**FINAL DRAINAGE REPORT FOR
HCD DRILLING
2601 EAST PLATTE AVENUE
COLORADO SPRINGS, COLORADO 80916**

July, 2021
Revised April, 2022

Job No. 1895.00
PCD Filing No.: MS-21-008

DETENTION BASIN OUTLET STRUCTURE DESIGN

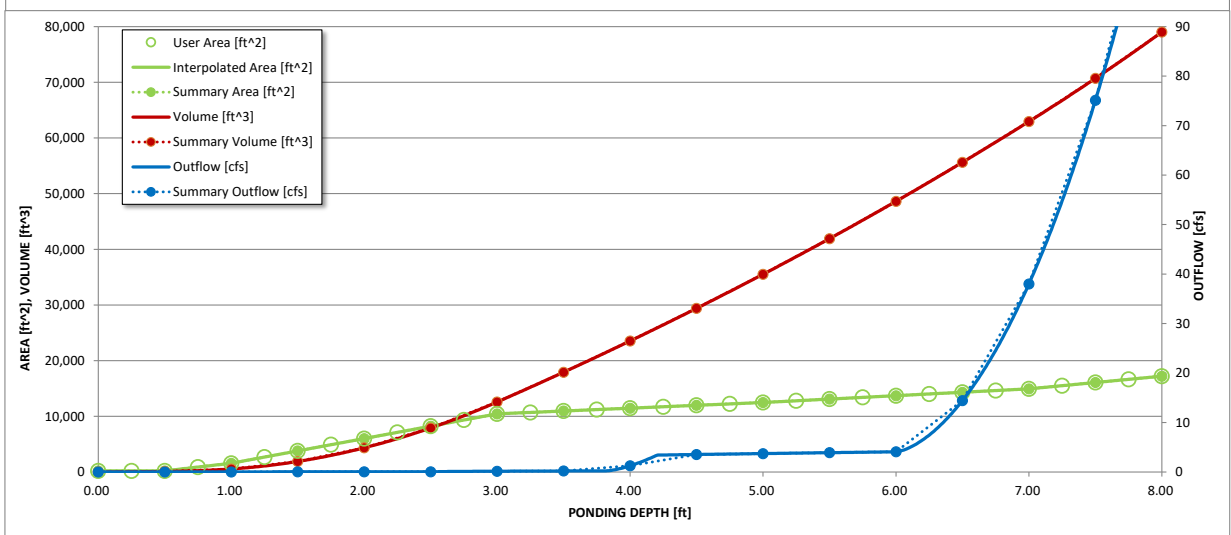
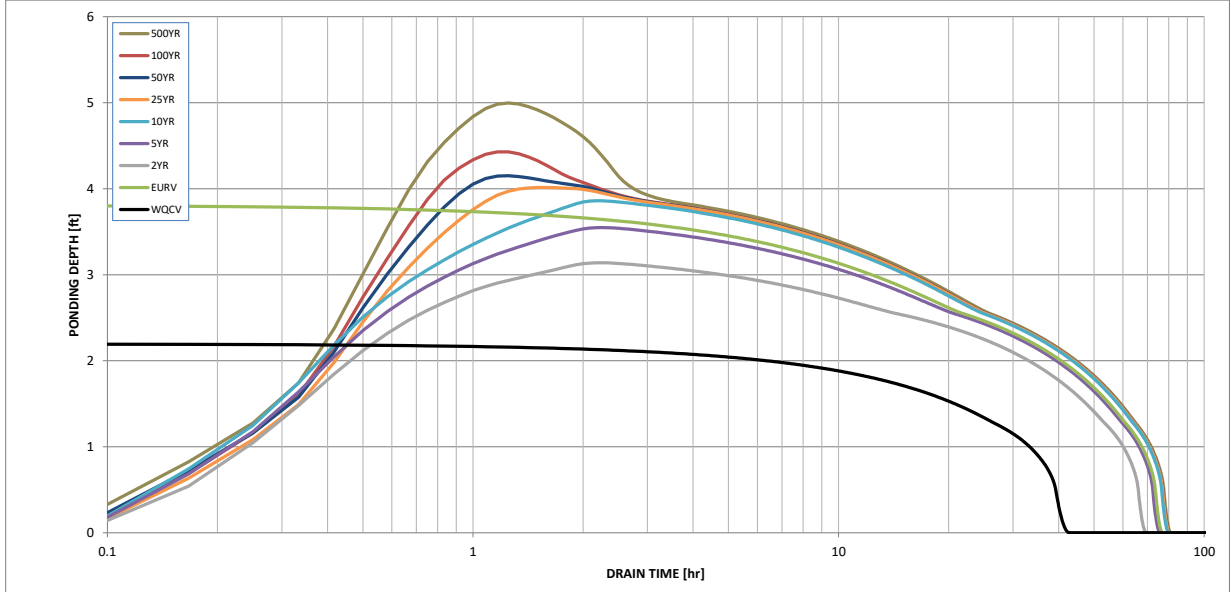
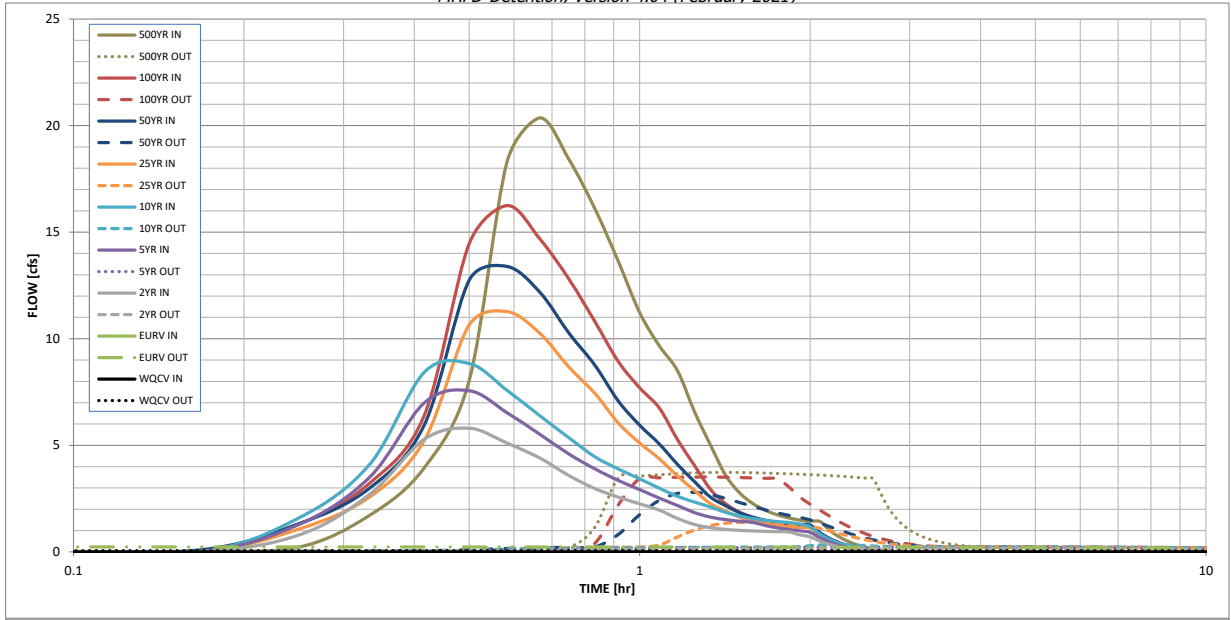
Update outlet structure design. For full spectrum design these must be equal to or less than predevelopment flows.
Unresolved

HCD DRILLING MINOR SUBDIVISION
6201 E. PLATTE AVE.
CONSTRUCTION DRAWINGS
DETAIL SHEET

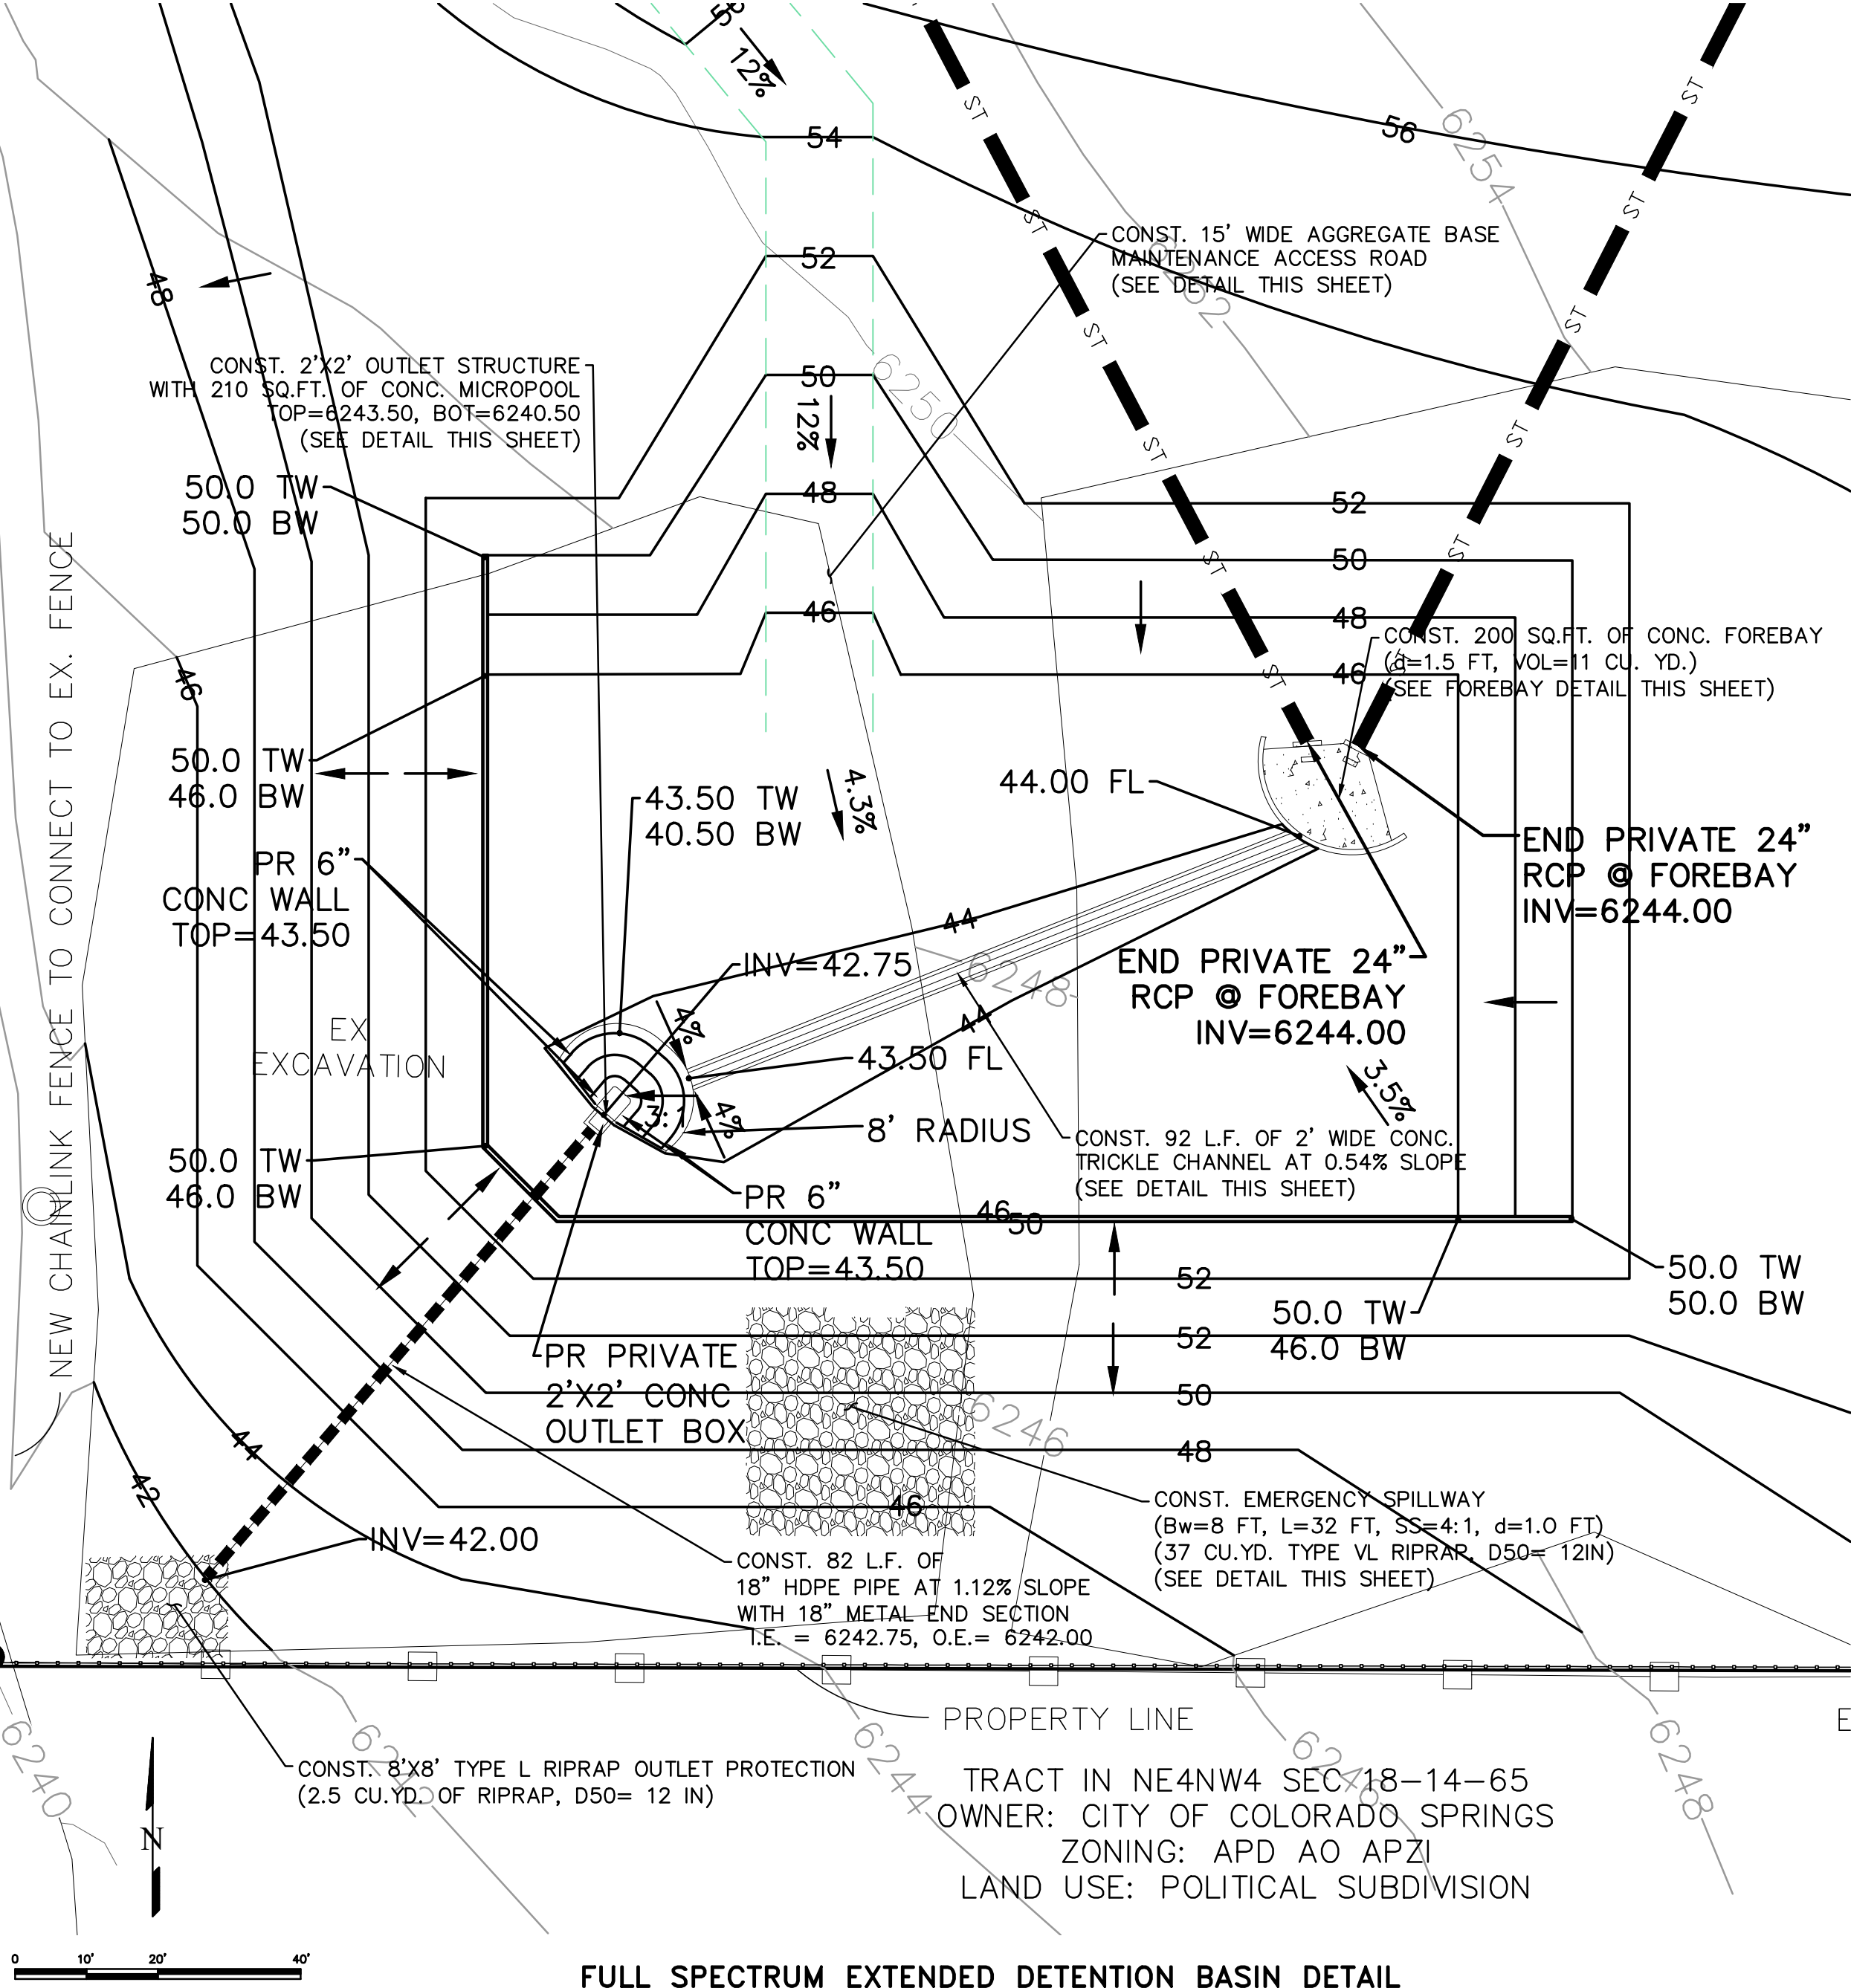
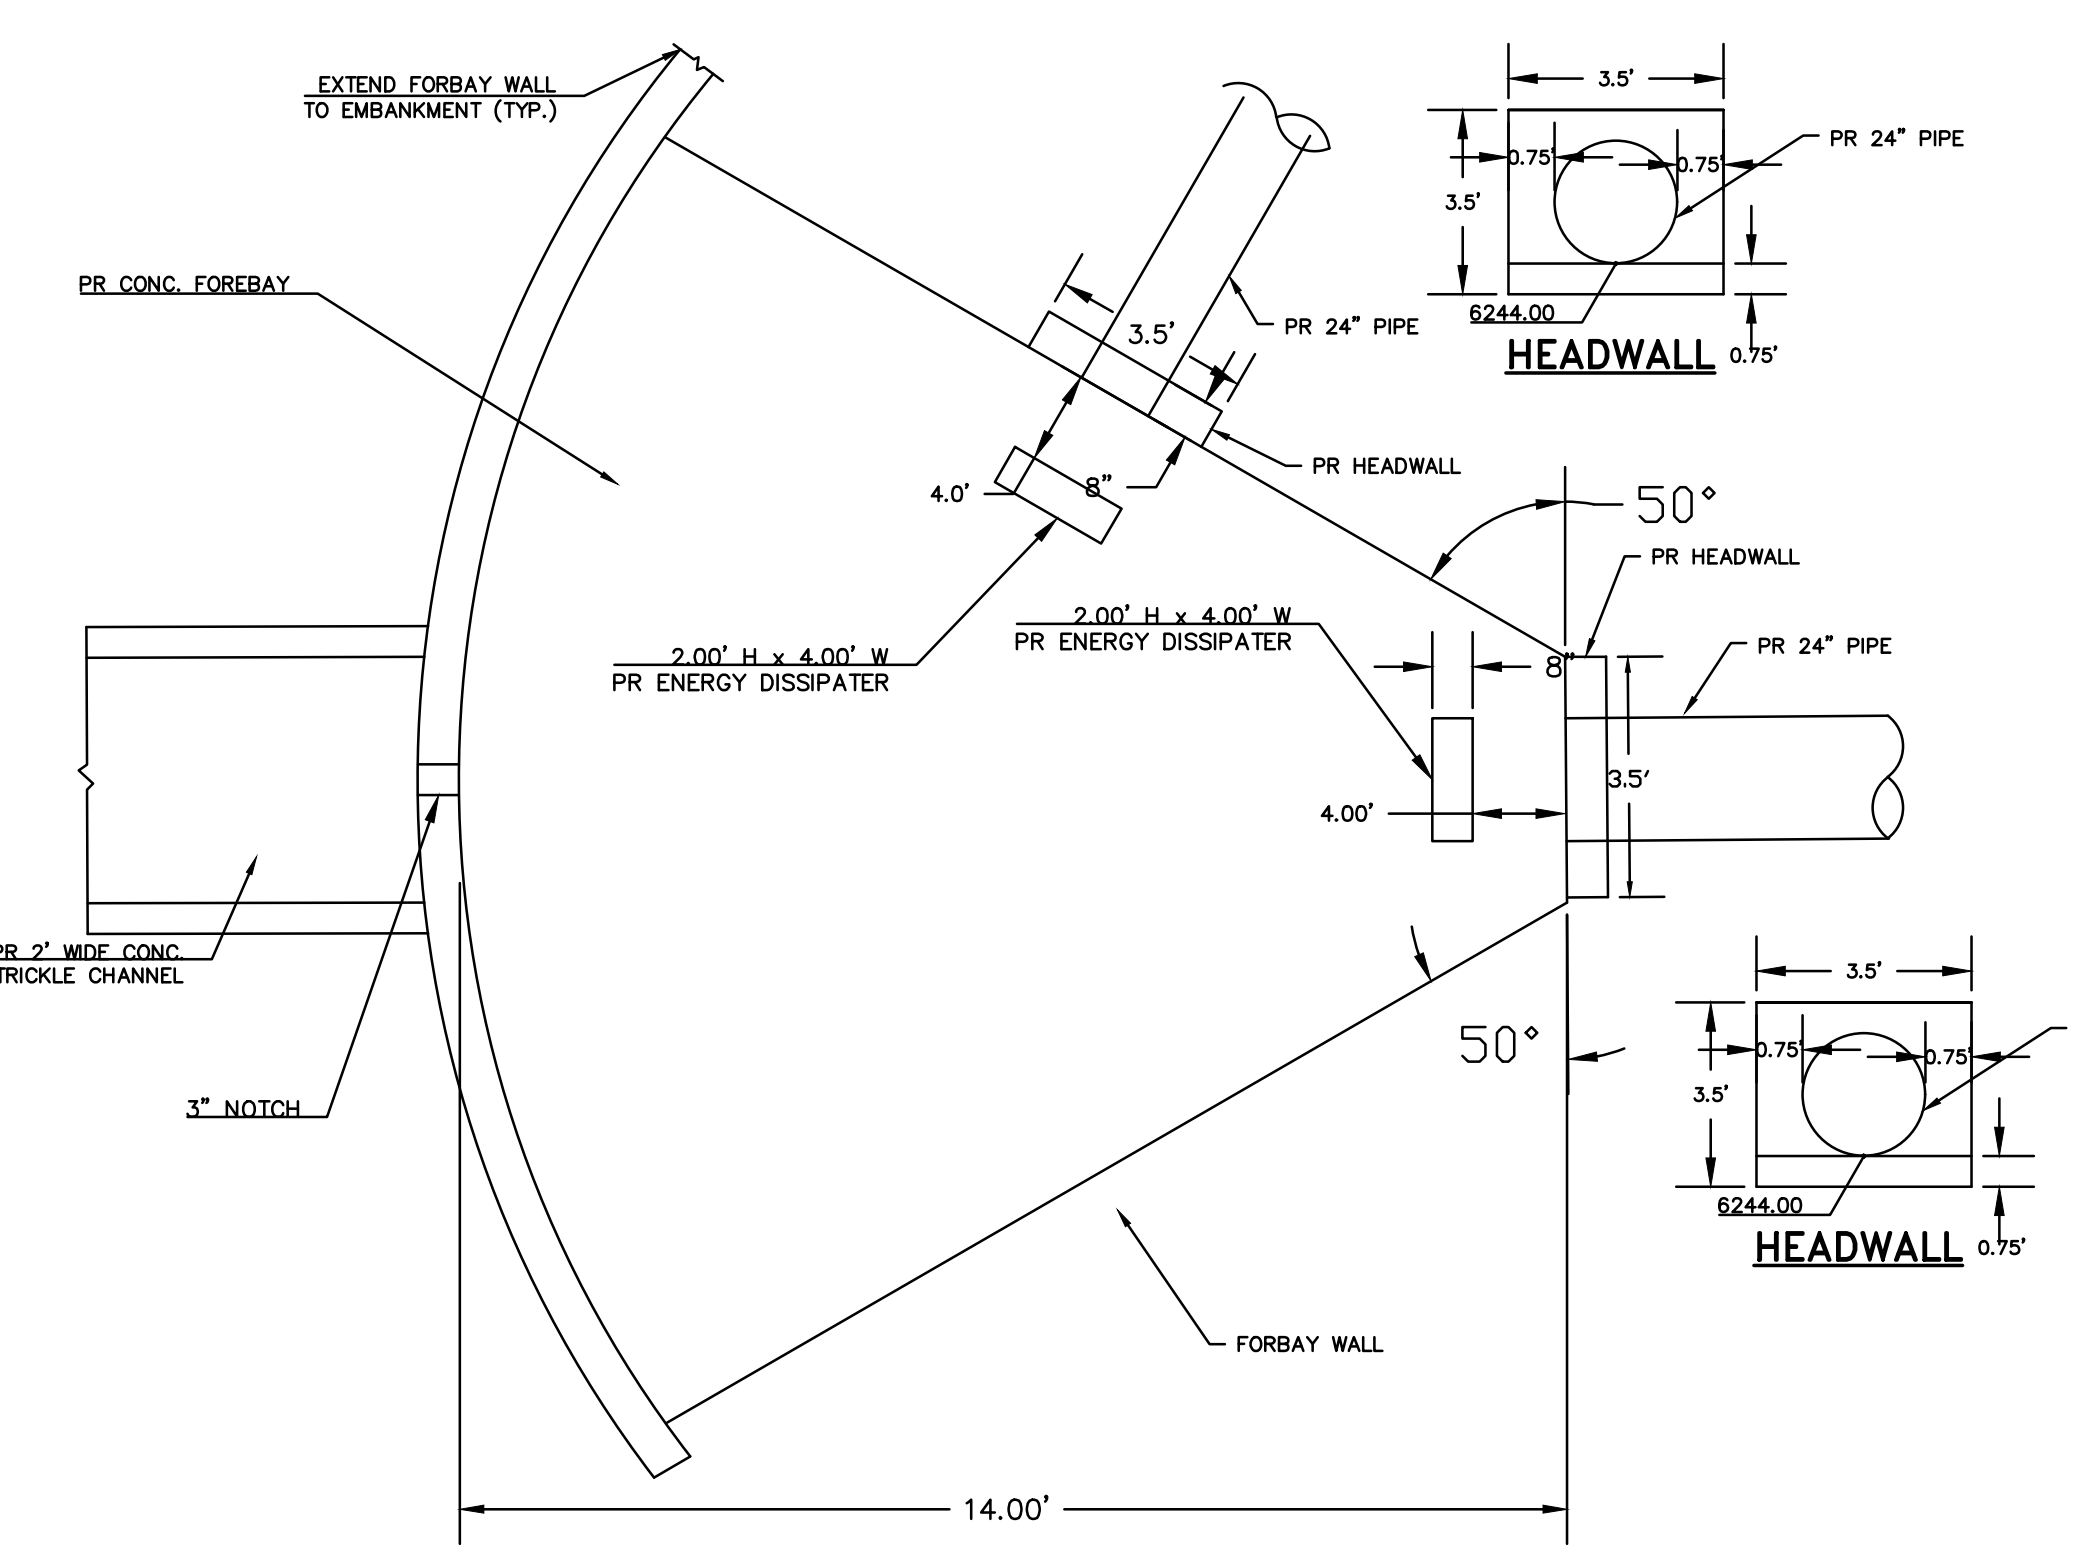
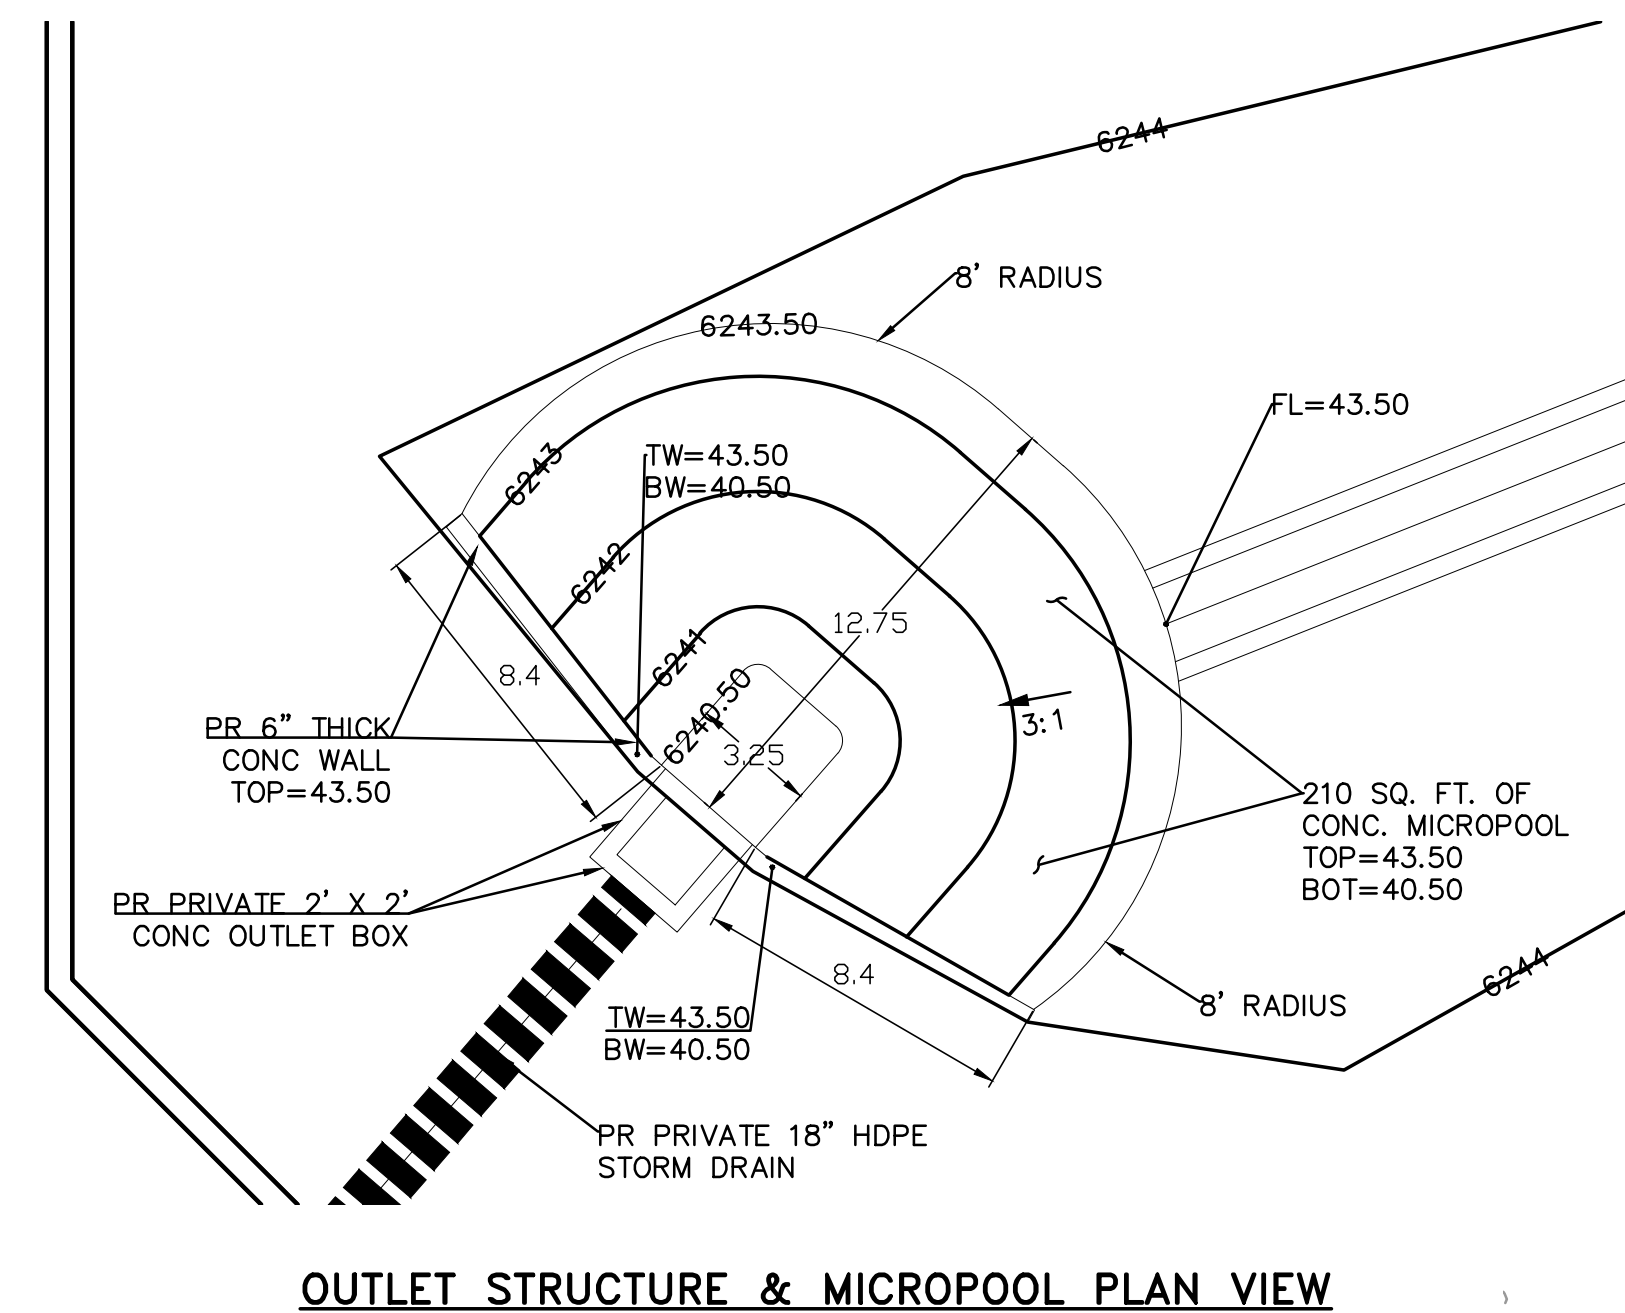
Remove Sheet.
Redline comments are cursory comments. Detailed comments will be provided to the construction drawings as part of the review of the site development plan application.
Unresolved.

Revise to identify the diameter of orifice.
